## DEVELOPMENT APPLICATION ASSESSMENT REPORT

<b>Application Number:</b>	DA2025/0195
----------------------------	-------------

<b>Responsible Officer:</b>	Julie Edwards
<b>Land to be developed (Address):</b>	Lot A DP 383963, 29 McDonald Street FRESHWATER NSW 2096
<b>Proposed Development:</b>	Alterations and additions to a dwelling house
<b>Zoning:</b>	Warringah LEP2011 - Land zoned R2 Low Density Residential
<b>Development Permissible:</b>	Yes
<b>Existing Use Rights:</b>	No
<b>Consent Authority:</b>	Northern Beaches Council
<b>Delegation Level:</b>	DDP
<b>Land and Environment Court Action:</b>	No
<b>Applicant:</b>	Nigel White

**Image 1:** Height of building variation.

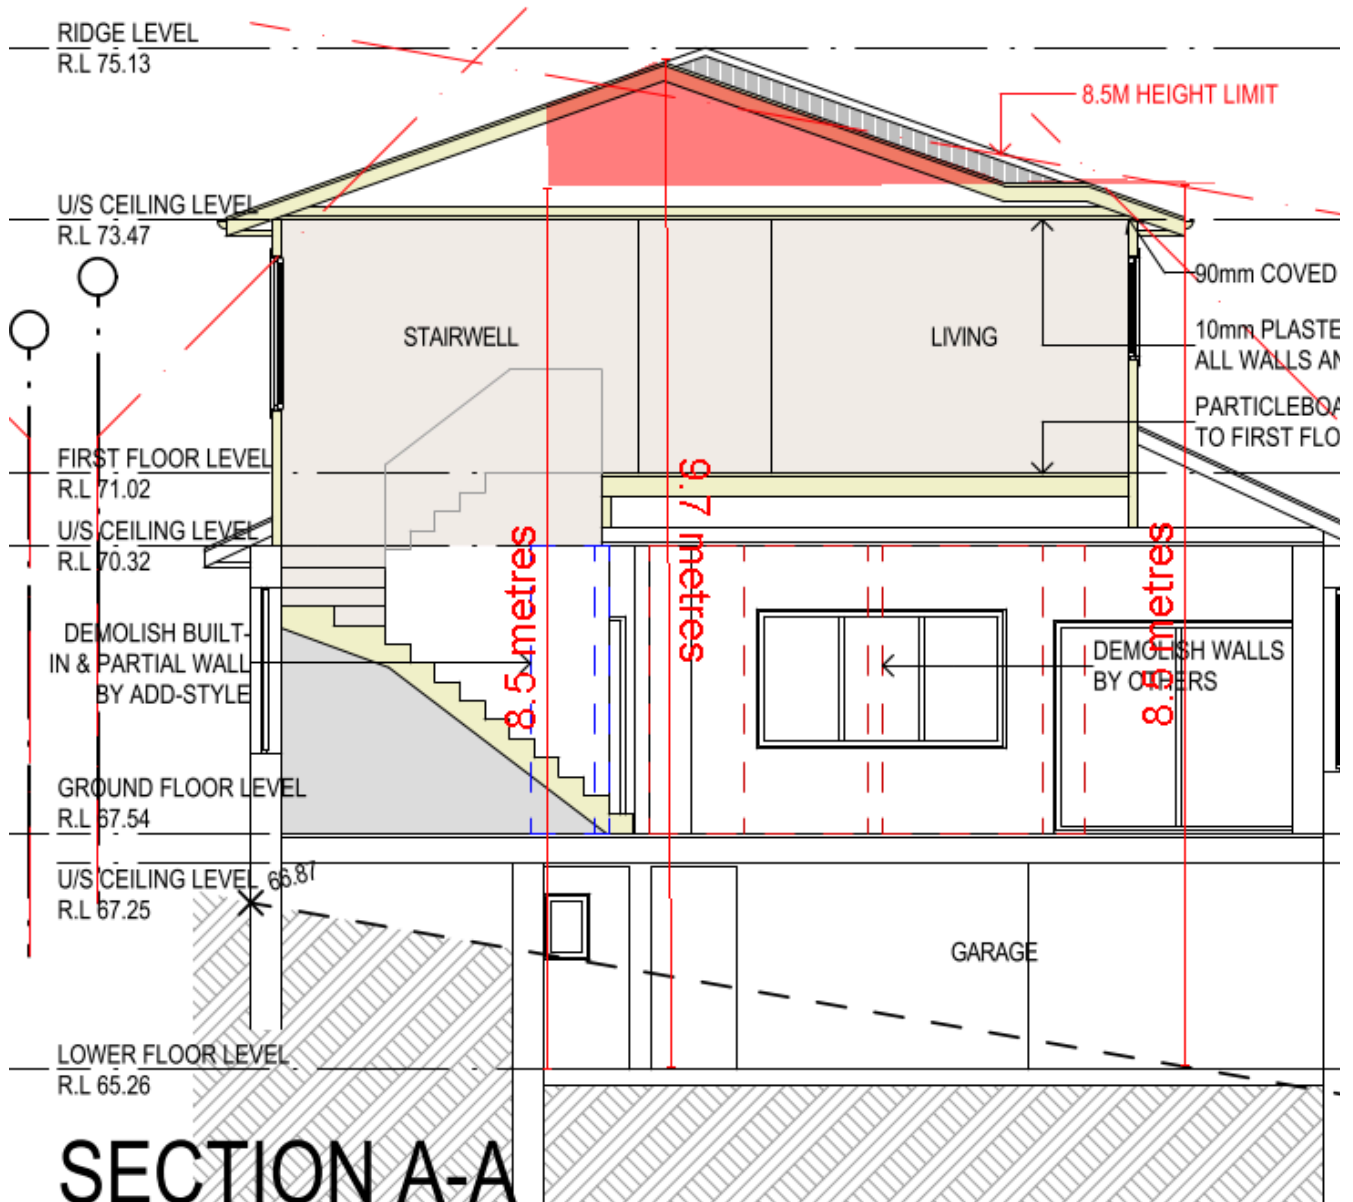
Development standard:	Height of buildings
Requirement:	8.5m
Proposed:	9.7m
Percentage variation to requirement:	14.11 %

The height breach as a result of the replacement roof light and front extension is lower than the maximum height of the existing dwelling and is in a location that will not contribute to any adverse loss of views, privacy or solar access.

The proposed height breach will not cause any adverse visual impacts when viewed from the surrounding public domain.

Council is satisfied that the Applicant has demonstrated that there are sufficient environmental planning grounds to justify the contravention of Clause 4.3 Height of Buildings for the following reasons:

The applicant has satisfactorily demonstrated that the works are consistent with the objects of the EP&A Act, specifically the following objects of the EP&A Act:

It is considered on balance, that having regard to the particular circumstances the proposed departure from height of buildings development standard is acceptable and it is reasonable that flexibility to the standard be applied.

**Image 2:** Encroachment into southern side boundary shaded in red.

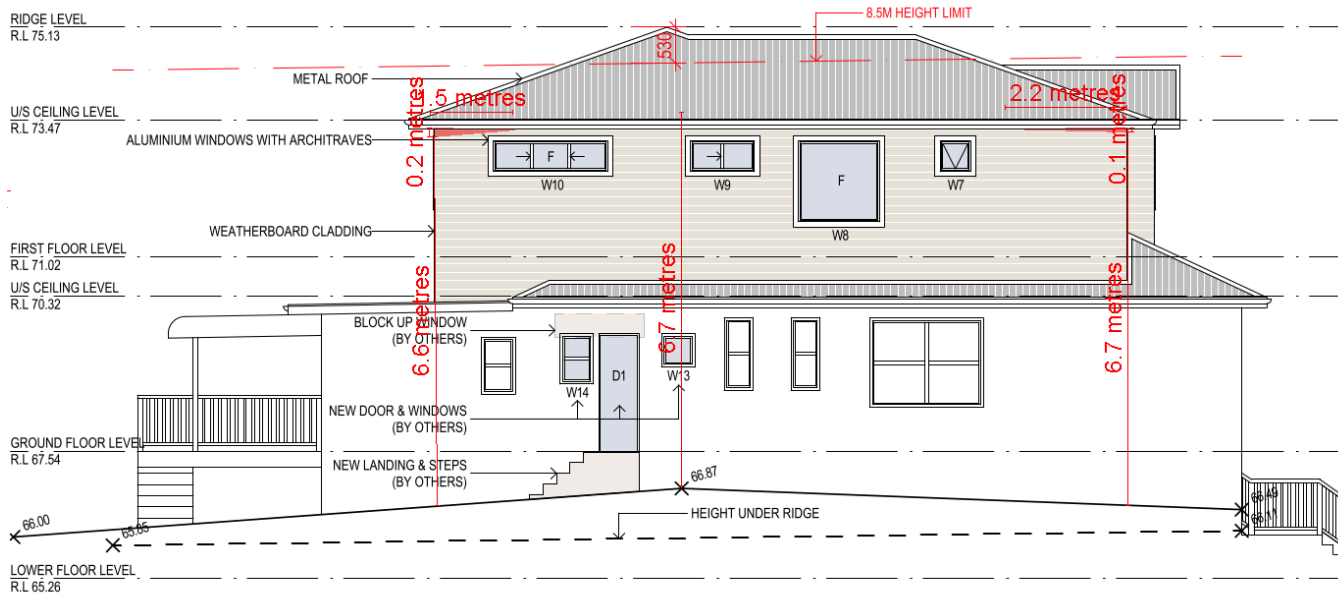
The control requires buildings to be sited within a building envelope which is determined by projecting planes at 45° from a height of 5m above the ground level at the side boundary.

The proposed first floor encroaches into the southern side boundary envelope in two places for a length of 1.5m and a height of 0.2m - nil and a length of 2.2m and a height of 0.1m - nil.

The proposed non-compliance with the building envelope control is not found to cause any unreasonable visual impacts. The dwelling is beneath the wall height requirement and appropriately setback from the side boundary. The overall built form is generally consistent with that of surrounding modernised development.

side boundary non-compliance is a result of the slope of the site and location of the existing dwelling. The proposal complies with the building height control of the WLEP and the front, side and wall height controls of the WDCP. It is considered that the addition is appropriately located to respond to the site topography. No unreasonable streetscape or amenity impacts are expected to arise as a consequence of the development.

Having regard to the above assessment, it is concluded that the proposed development is consistent with the relevant objectives of WDCP and the objectives specified in s1.3 of the Environmental Planning and Assessment Act, 1979. Accordingly, this assessment finds that the proposal is supported, in this particular circumstance.
